6-November-2020

RE: Response to Technical Evaluation Comments and Information Request
#3 for Underground Injection Control (UIC) Permit Application Class VI
Pre-Construction Permit Application No. R9UIC-CA6-FY20-1

Figure 1: Well log upscaling of the two nearest wells over the Second Panoche Sand (from Petrel 2019).

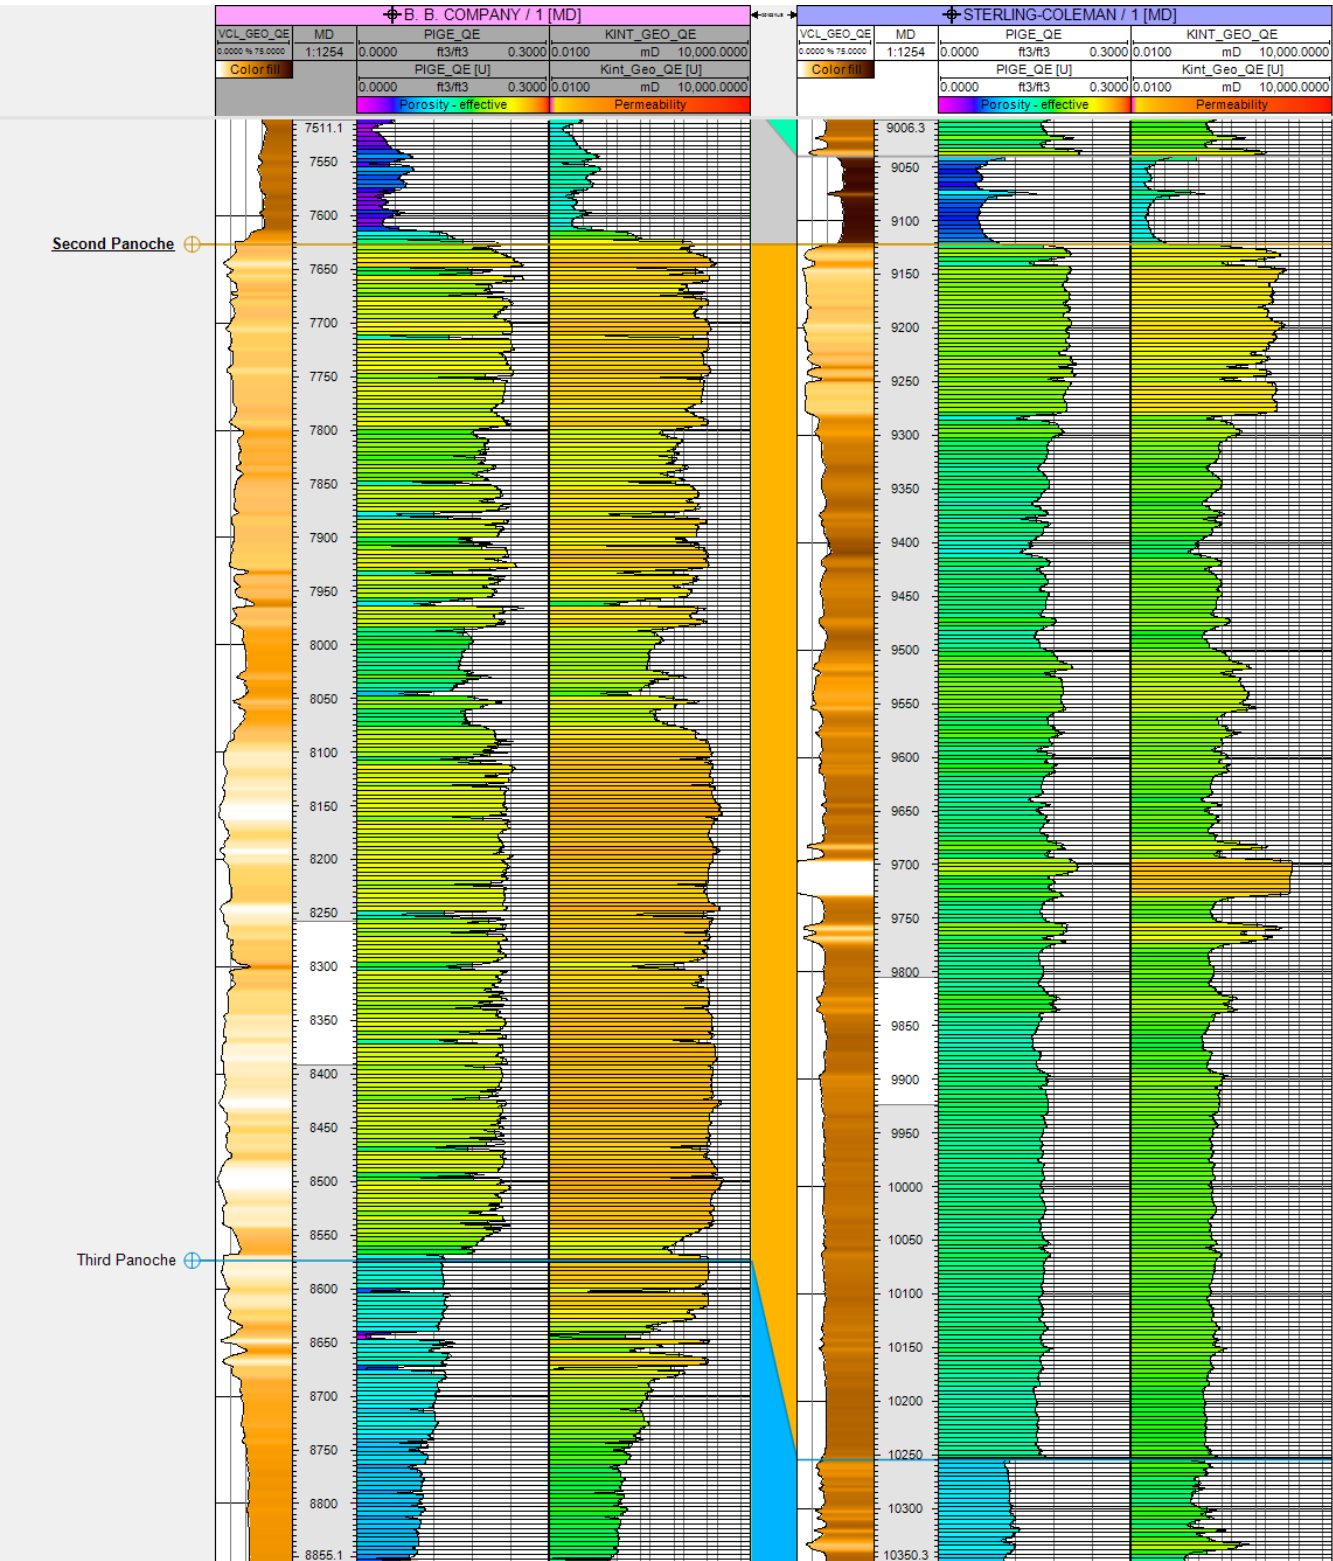
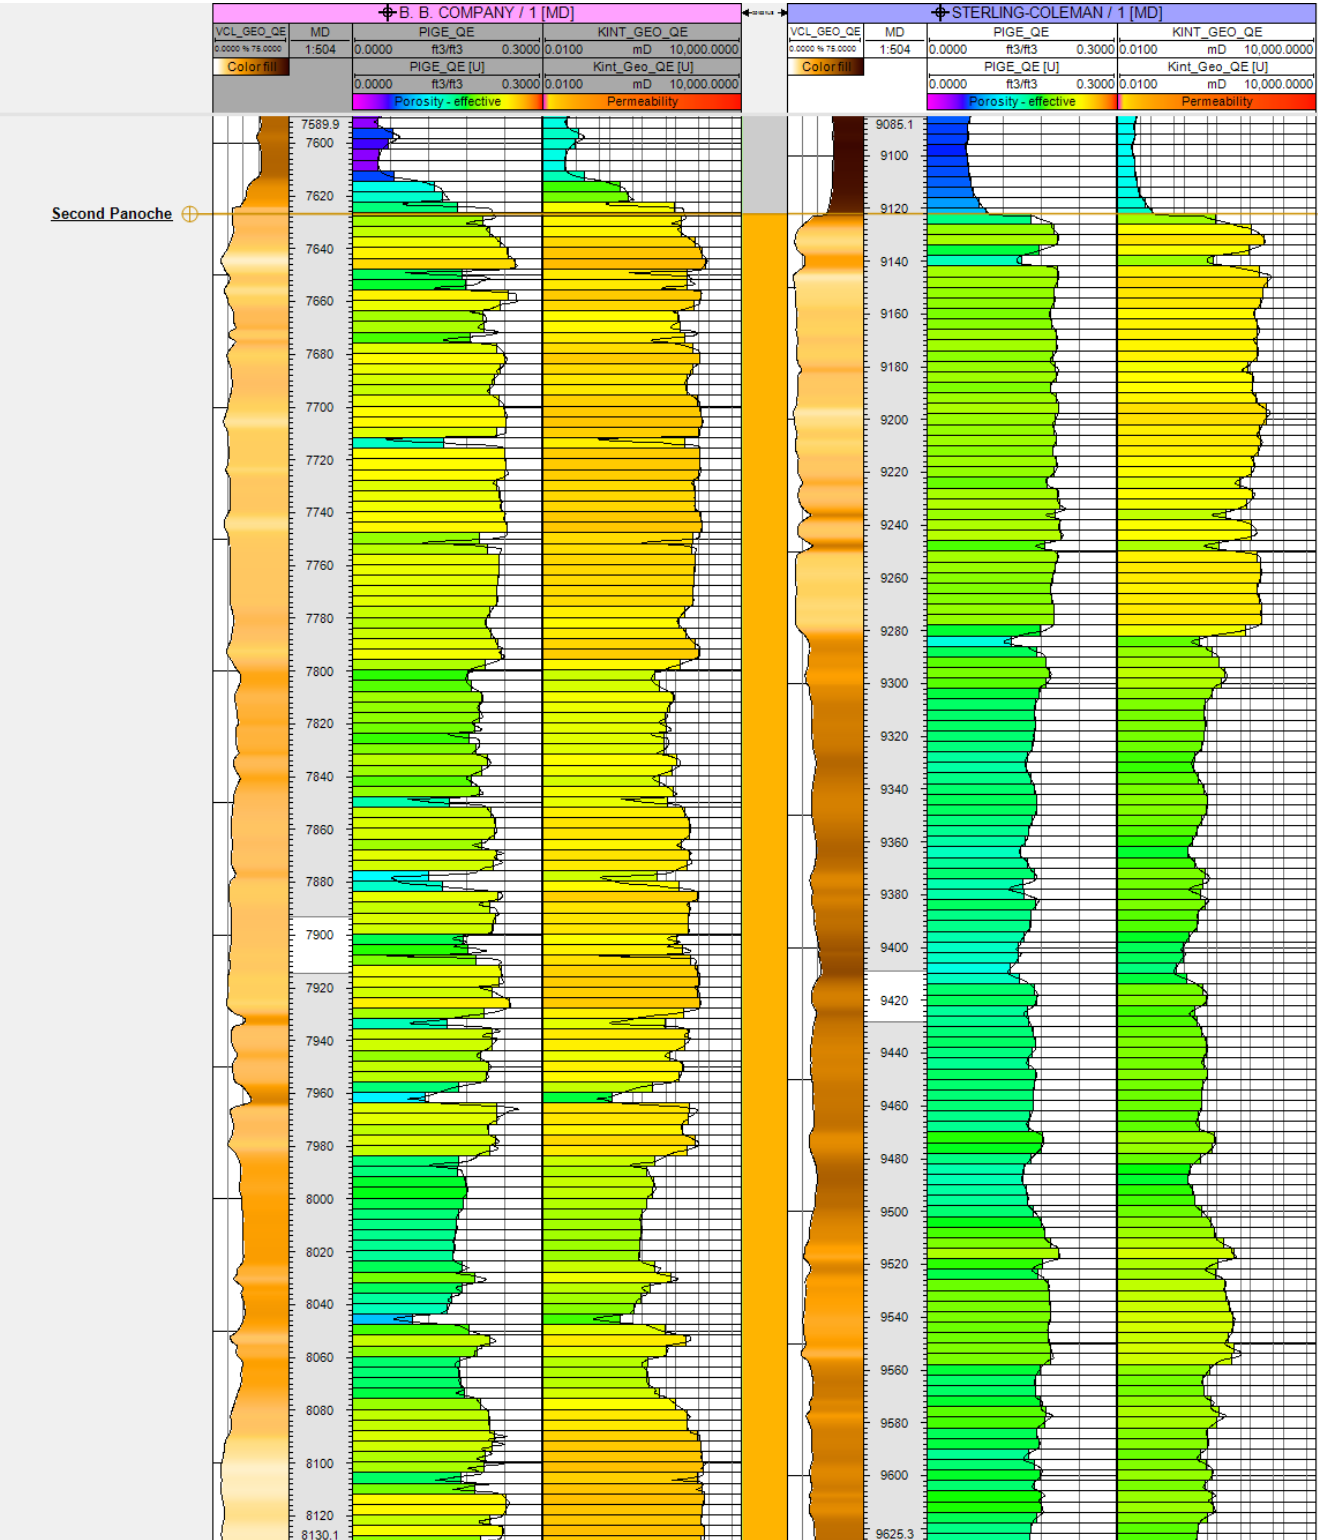
- What method was used to upscale the petrophysical properties along the wellbores of the 10 wells for which logging data were used? How was upscaling handled for the different formations? How was the success of this method evaluated?

- *Effective porosity and permeability were upscaled using arithmetic averaging methods. Although the geometric mean upscaling method can be used for permeability, in this case, the arithmetic method was most representative of the well logs. Please refer to Figure 1 and Figure 2 in Appendix A. Layer thicknesses are constant per modeled zone. Upscaling results were quality checked using histograms and crossplots comparing the raw and upscaled data. Histograms and crossplots show a reasonable match throughout the modeled zones.*

Figure 3: Porosity-permeability crossplot model cells colored by formation (from Petrel 2019).

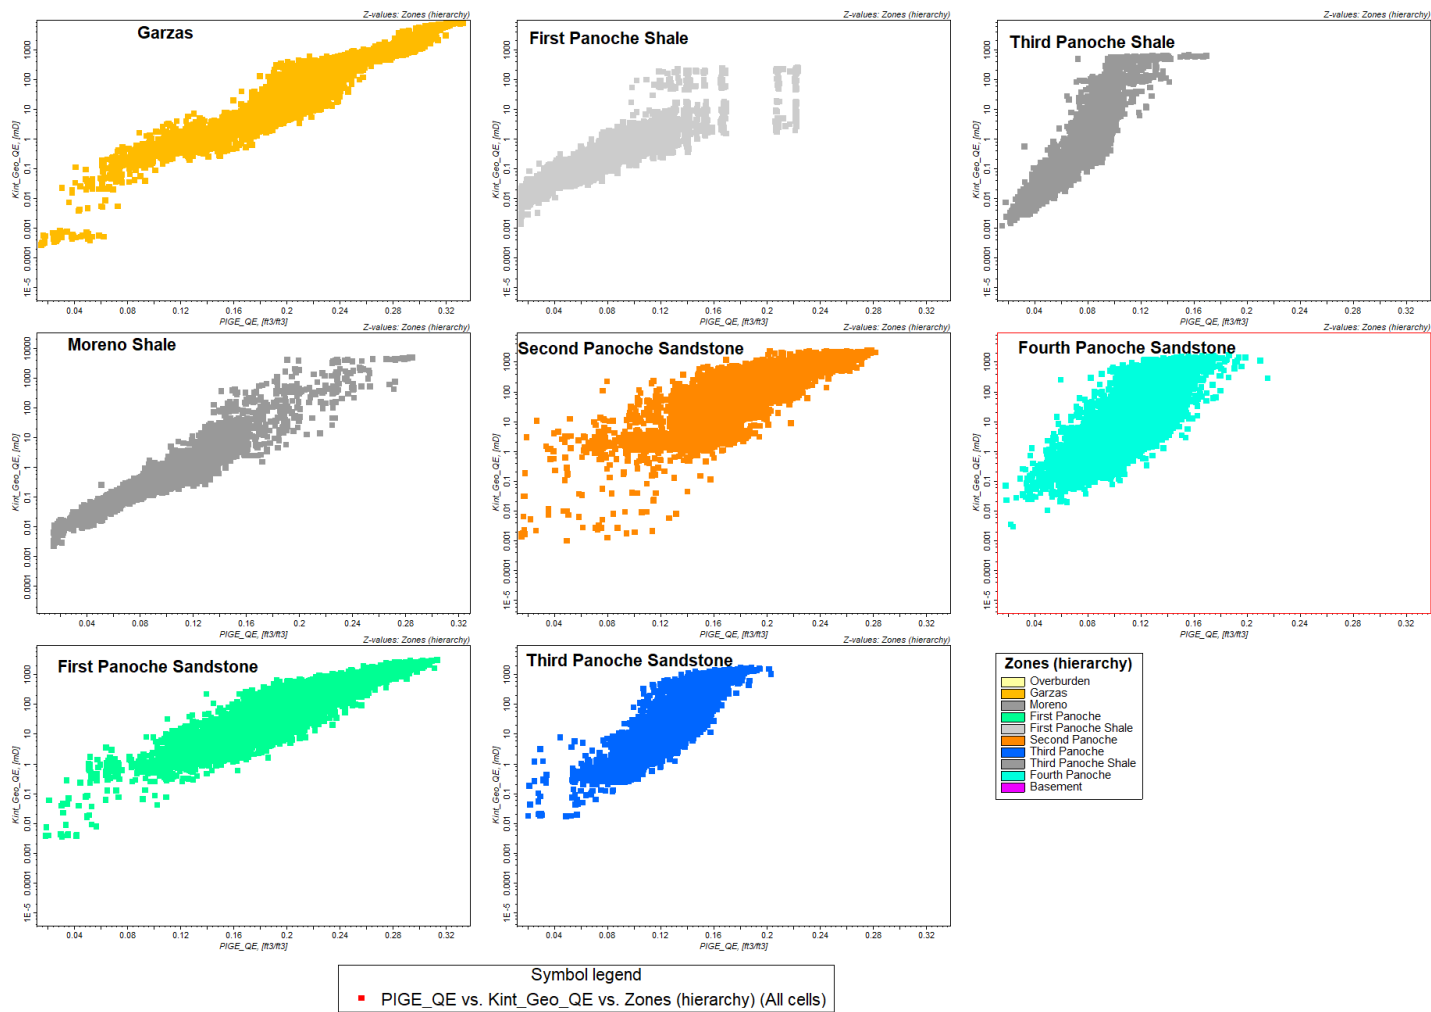
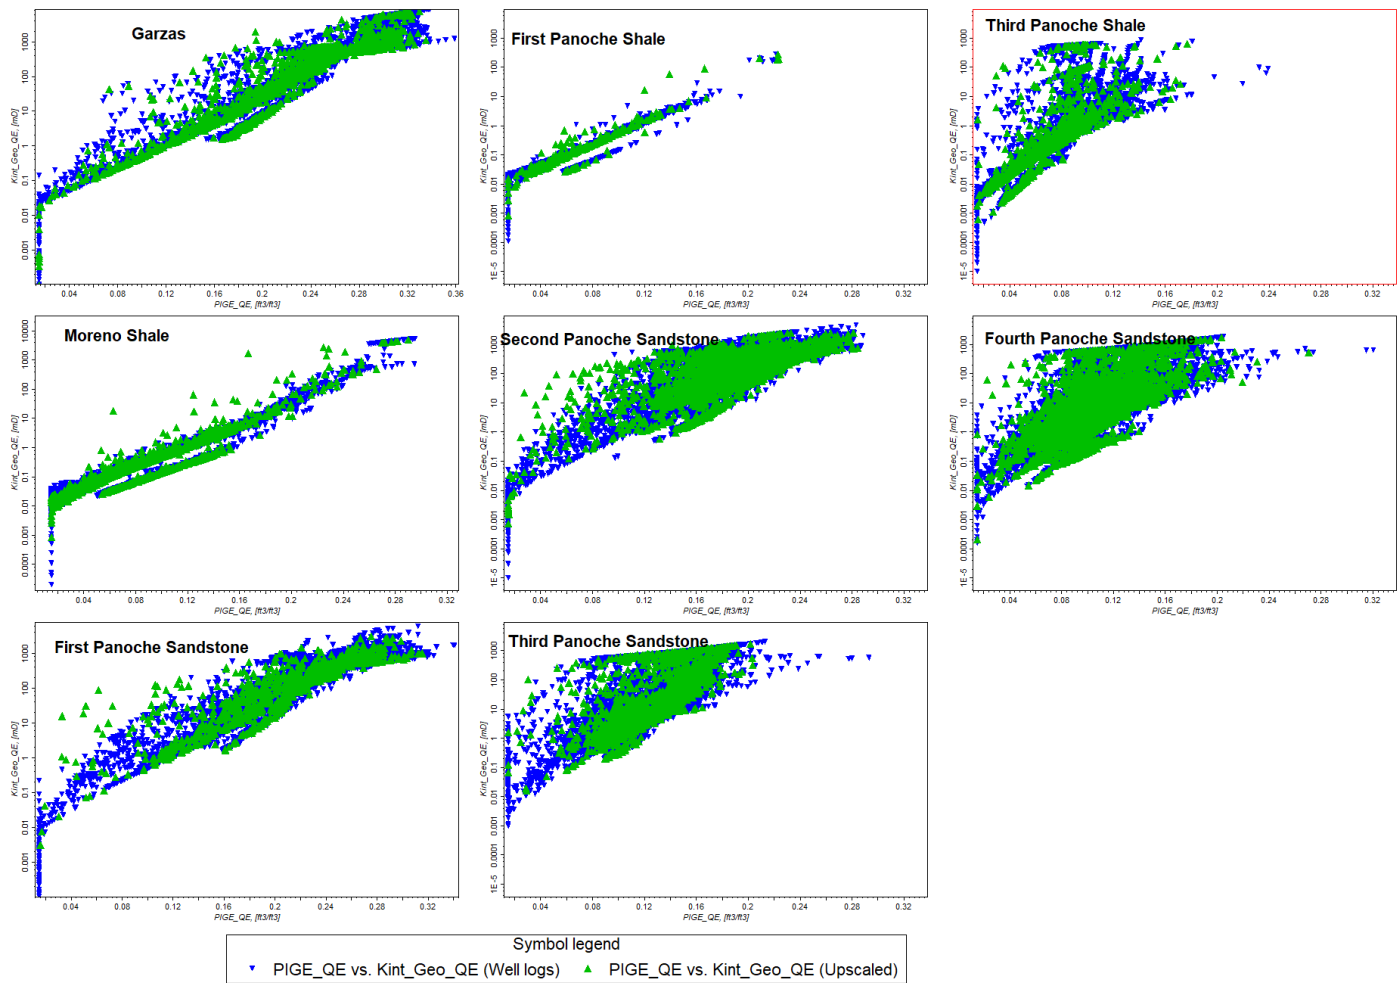
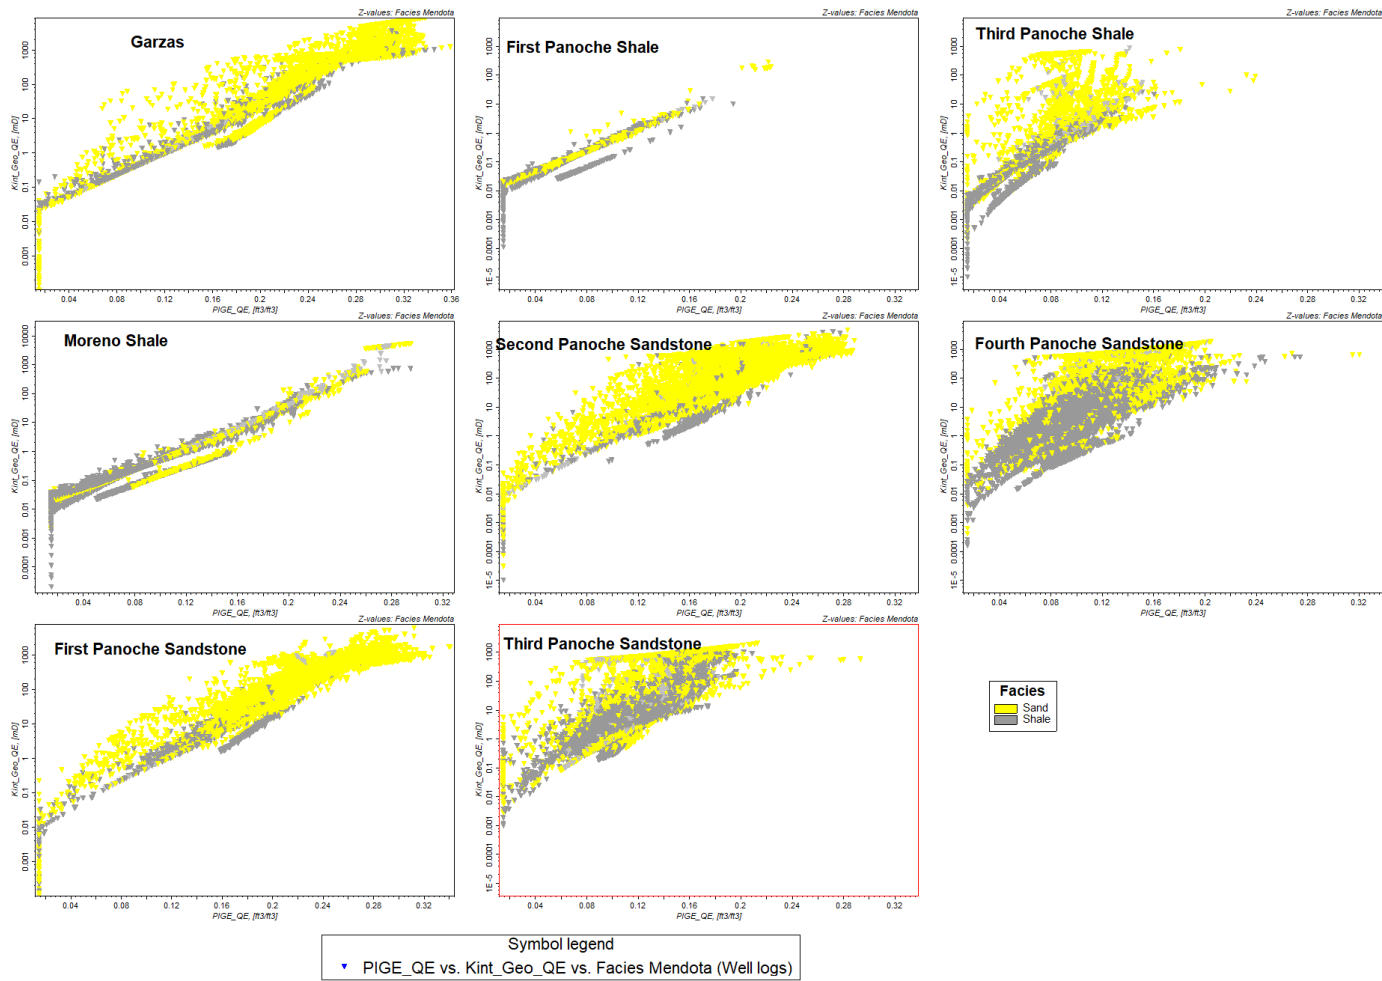
- In the plot of well log-derived data points, upscaled values, and full-field simulated cells, the

upscaled values dominate. It appears that the upscaled value symbols may have been layered over the other symbols. Please revise the figure to show the distributions of all three types of data points more clearly.

The graph in Figure 30 of the narrative showing porosity vs. permeability by formation is labeled as Z values and the legend title is “Zones.”

- Please clarify the meaning of the zones in the legend of Figure 30. Are they equivalent to the formations, as suggested by the legend?
 - *Zones are equivalent to formations. For clarity, Figure 30 has been updated and divided into Figure 3, Figure 4, and Figure 5 in Appendix A.*

- *For clarity, Figure 30 has been subdivided into three figures. Please refer to Figure 3, Figure 4, and Figure 5 in Appendix A.*
- Are there any concerns about autocorrelation since the permeability was based on porosity and lithology? If so, how was this issue addressed?

- Were the graphs in Figure 30 the basis for assigning phi and k in the layering in the model domain?
 - *For clarity, Figure 30 has been updated and divided into Figure 3, Figure 4, and Figure 5 in Appendix A. The graphs show the unique porosity/permeability relationships per zone. The corresponding variables were used in the layering model.*

In comparing Figure 1 in the Rock Type file with Figure 30 of the narrative, the facies in Figure 30 show a broad spread rather than the sharp dividing line in Figure 1. It appears that a number of shale data points in Figure 30 were assigned to the sandstone facies by the neural network training method in Figure 1. There also appears to be a significant difference in porosity between the Fourth Panoche and the Second Panoche Sands in Figure 30.

- Are the porosity differences between the Second and Fourth Panoche Sands sufficient to possibly warrant a third rock type?
 - *The Fourth Panoche Sandstone appears more laminated in nature than the Second Panoche Sandstone, which appears blocky or channelized and which, therefore, may exhibit differences in porosity. It is possible a third, fourth, or fifth rock type will be required to characterize all zones. After additional well log data are acquired, it will then be determined how many more rock types will be defined.*

- *The facies model described in Figure 30 (updated with Figure 5) was a preliminary estimate to perform fault seal analysis. This facies log was not used as part of the petrophysical model interpolation. The rock classification methodology (neural network) was used to create the hydrofacies interpretation needed for dynamic modeling. Porosity and permeability of the geocellular model were upscaled to a tartan grid used for dynamic modeling. Please refer to Figure 6 in Appendix A.*

- Please discuss how these two methods of assigning facies were used to inform the geomodel and, consequently, the numerical model.
 - *The facies model described in Figure 30 (updated with Figure 5) was only constructed to characterize fault seal analysis; it was not used to inform the geomodel. The rock typing methodology with neural network was applied for the classification of hydrofacies (rock types) to assign relative permeability and capillary pressure functions in the dynamic modeling.*

- *The rock types presented in Figure 30 of the narrative, which are updated in Figure 5, were used for fault seal analysis. The petrophysical property interpolations were completed on a zone-by-zone basis and did not use these facies types in the petrophysical modeling. For example, the unique petrophysical properties (Figure 3) for the Fourth Panoche Sand are accounted for in zone-specific petrophysical modeling. After well log data are acquired, the rock typing will be calculated using a more advanced methodology such as HRA. Likely, this analysis will focus on three to five different rock types, thus enabling characterization of the Second Panoche Sand and other potential injection sands. Different shale classes will be informed by core mineralogy and digital log responses for various shale seals such as the First Panoche Shale (primary) and Moreno Shale (secondary).*
